Logan-Union-Champaign regional planning commission

Zoning & Subdivision Committee

Thursday, December 14, 2017

Staff Report – Darby Braeside

L:\Projects\Projects\A-E\0320001\CAUS\Sheets\04 - ROAD PLAN AND PROFILES.dwg, Last printed: 11/22/2017 2:22 PM

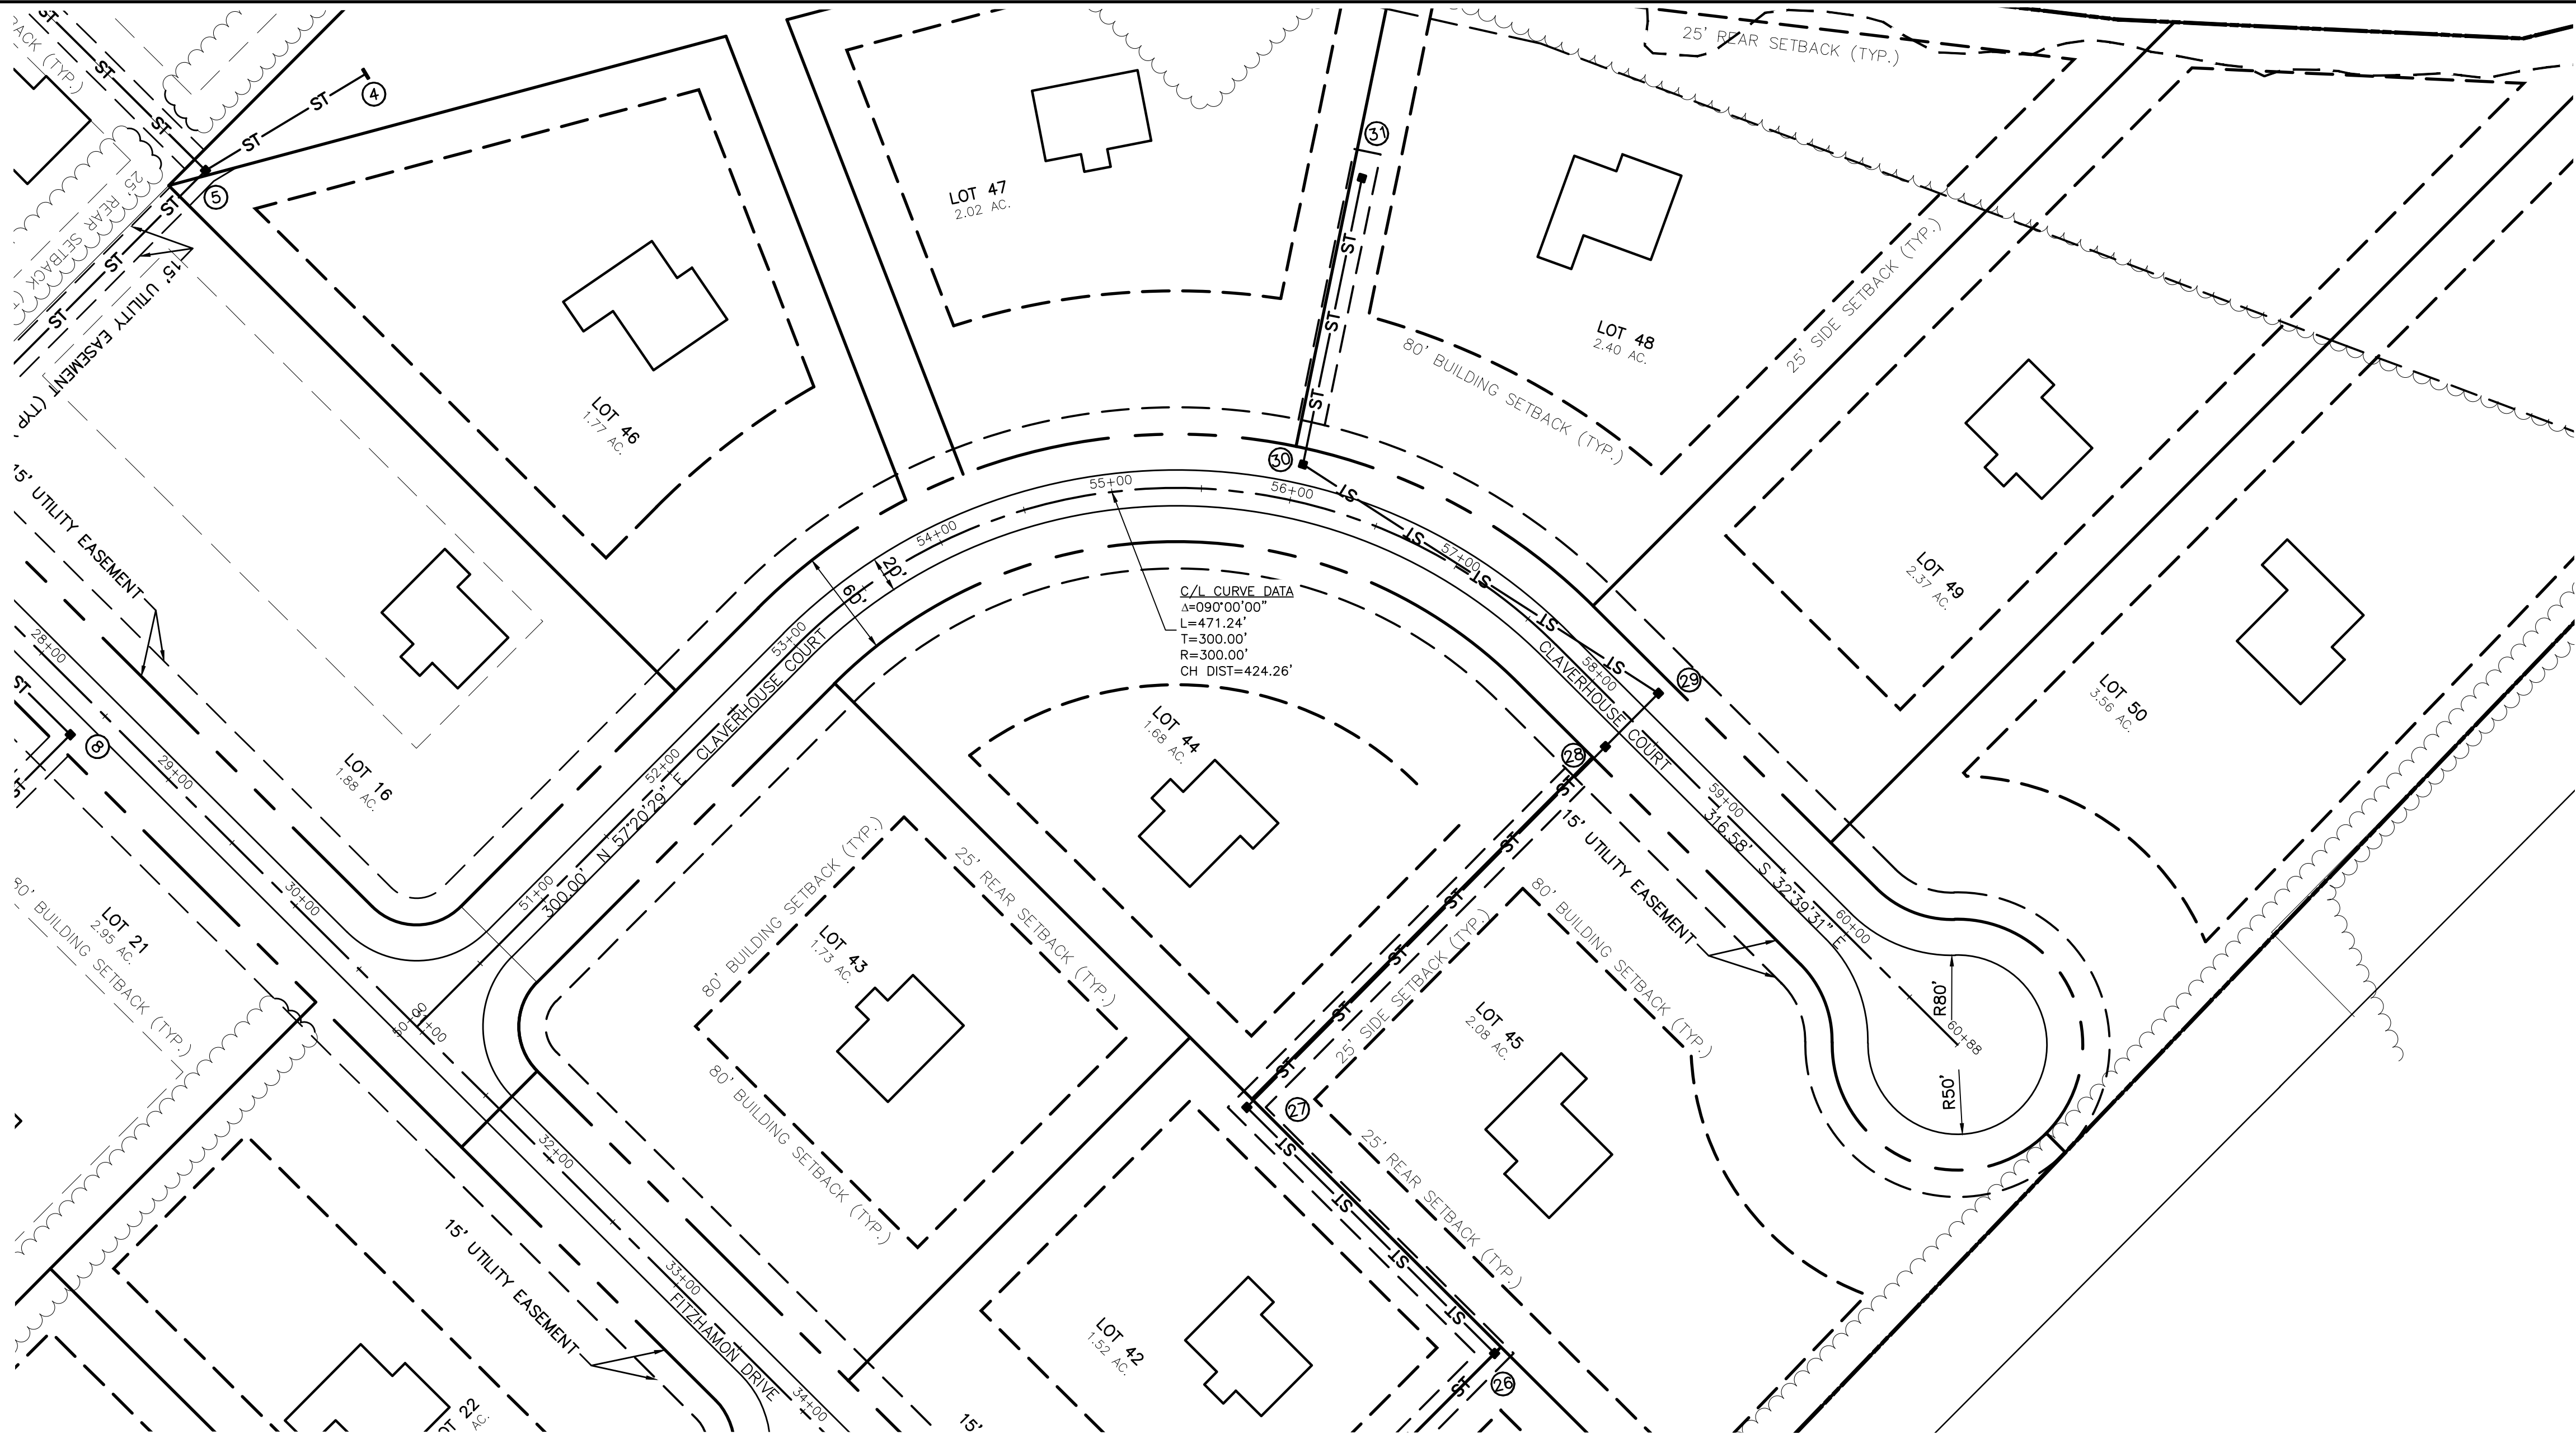
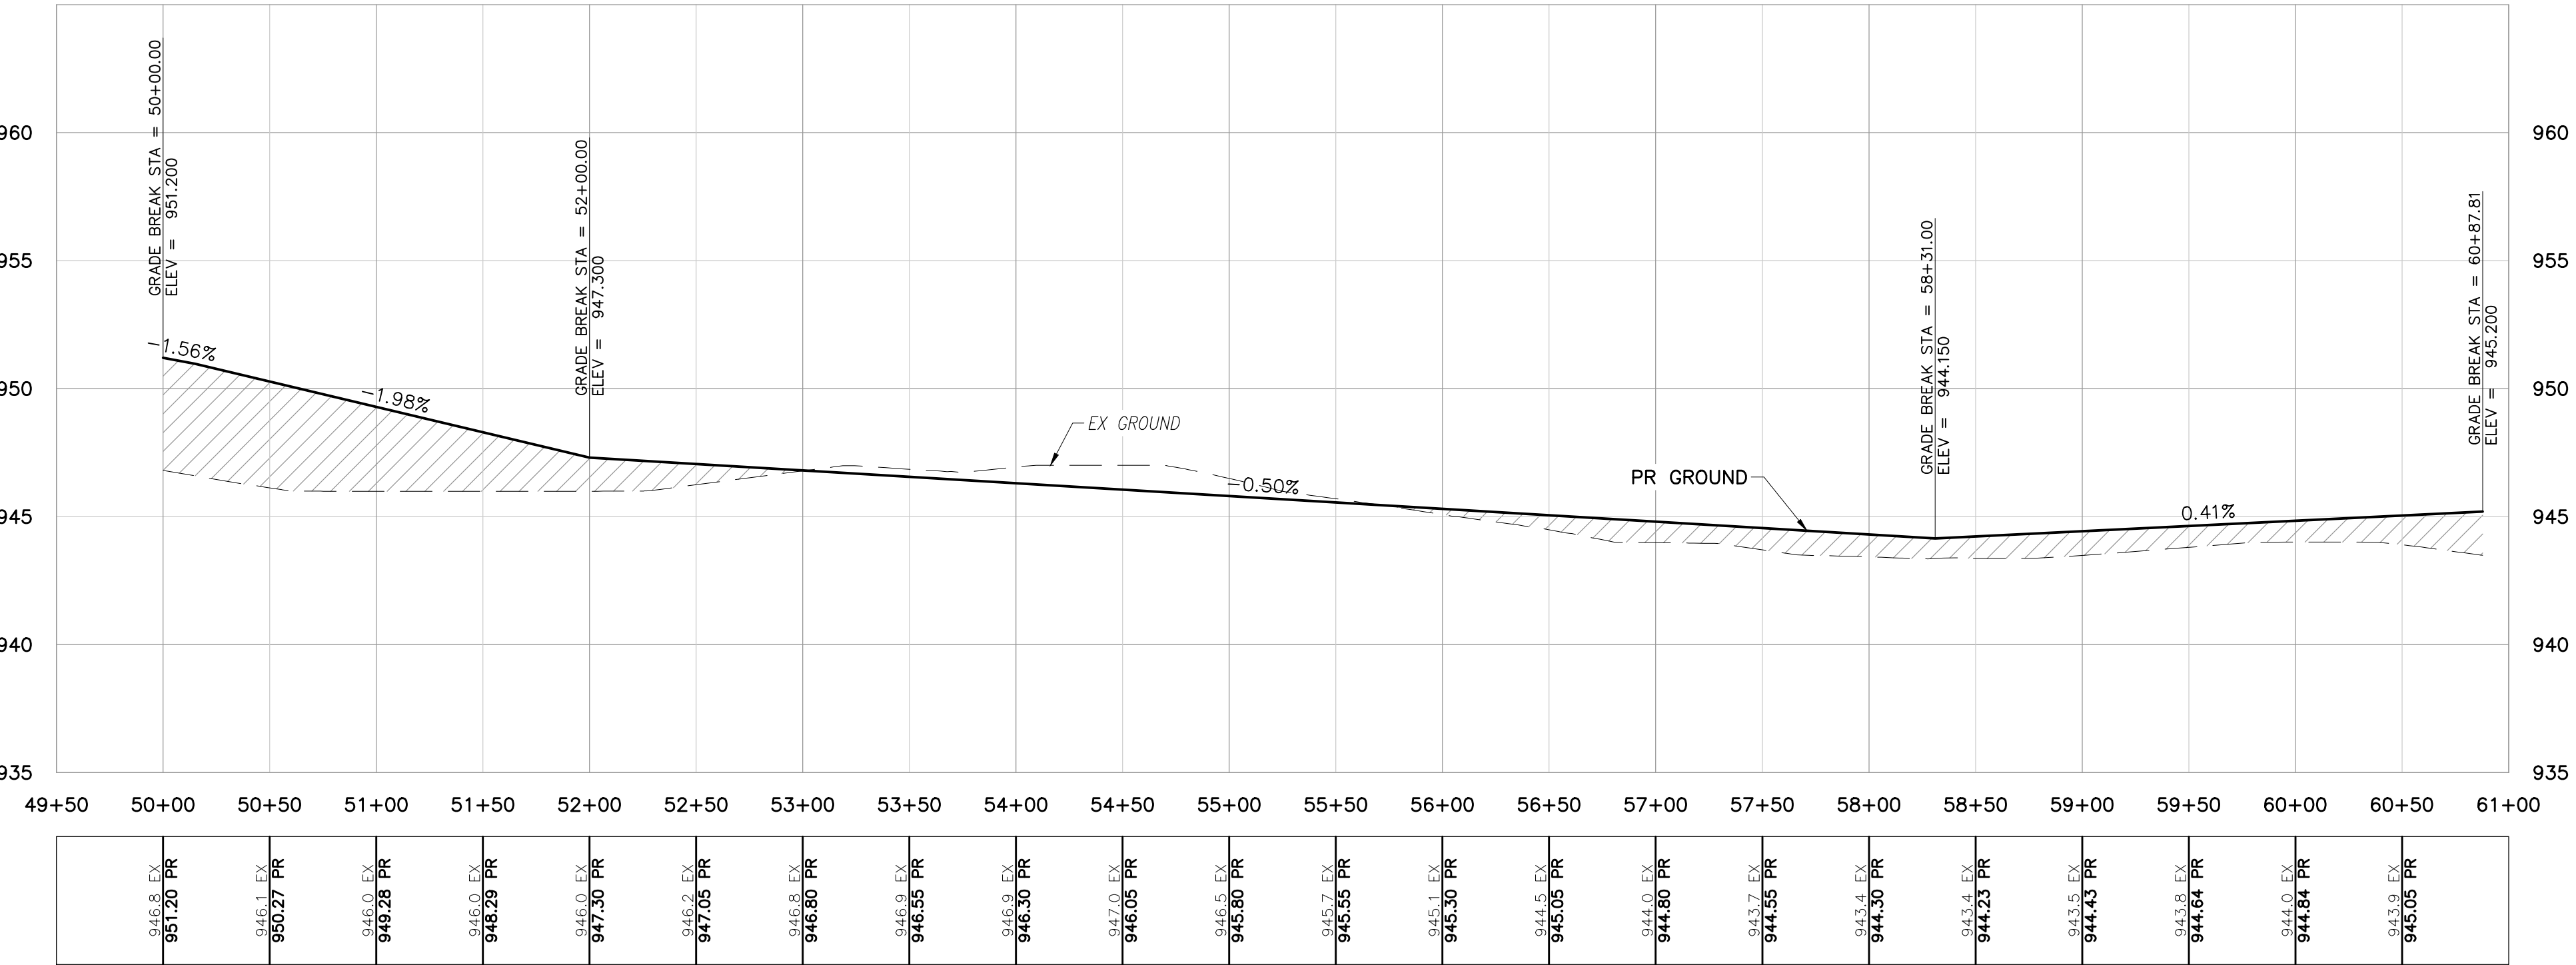
- 3) Sheet 3 of 19 – Existing Conditions
 - a) No comments
- 4) Sheet 4-8 of 19 – Roadway Plan & Profiles
 - a) URE to work with developer Engineering firm to establish offset easements between lots for primary or secondary facilities.
